**BEFORE  
THE PUBLIC SERVICE COMMISSION OF  
SOUTH CAROLINA**

**DOCKET NOS. 2019-224-E and 2019-225-E**

South Carolina Energy Freedom Act (House  
Bill 3659) Proceeding Related to S.C. Code  
Ann. Section 58-37-40 and Integrated  
Resource Plans for Duke Energy Carolinas,  
LLC and Duke Energy Progress, LLC

**DIRECT TESTIMONY OF KEVIN LUCAS**

Figure 1 - Natural Gas CC Additions by Scenario

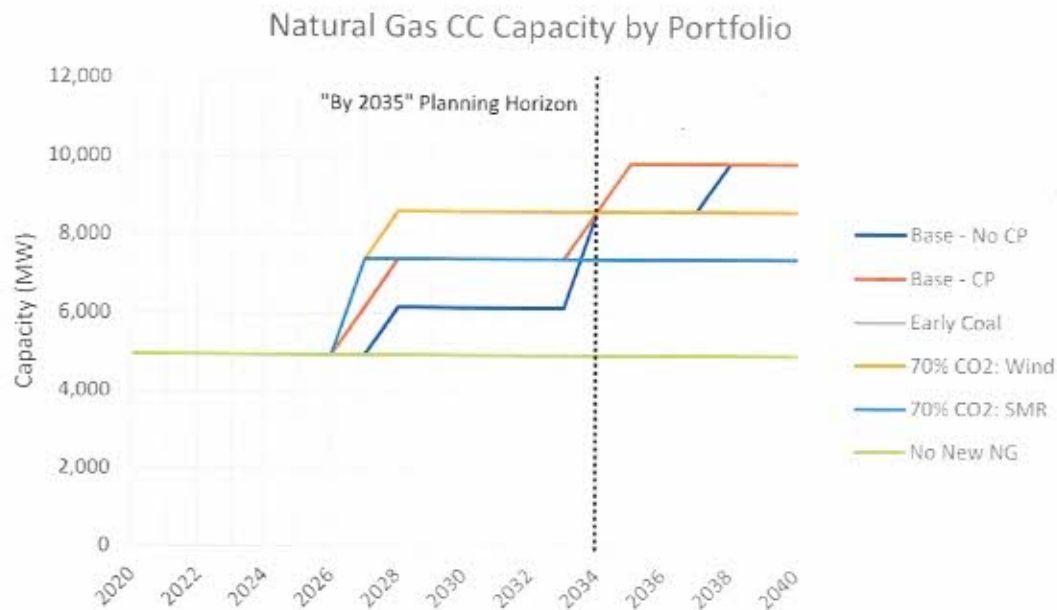
By 2035, the first three scenarios add three new 1,224 MW CCs while increasing CT capacity by roughly two-thirds (Base with Carbon Policy) or more than double (Base without Carbon Policy and Earliest Practicable Coal Retirement). The 70% CO<sub>2</sub>: High Wind adds fewer CTs through 2035, offset by increasing battery deployment. Unsurprisingly, the No New Gas Generation portfolio adds no new gas generation.

As dramatic as are the additions by 2035, the additional builds through 2040 are truly staggering. The two Base cases each add another 1,224 MW CC facility. The Base without Carbon Policy more than doubles incremental CTs, bringing nearly 7 GW of additional capacity online by 2041. The Base with Carbon Policy portfolio adds nearly as much, with 6.4 GW of new CTs. These additions represent the largest proposed natural gas expansion of any utility in the country by far.<sup>39</sup> Figures 1 and 2 below show the annual additions under each scenario, revealing that much of the natural gas build that was modeled rests just outside of the 15-year planning horizon in Duke's IRP.
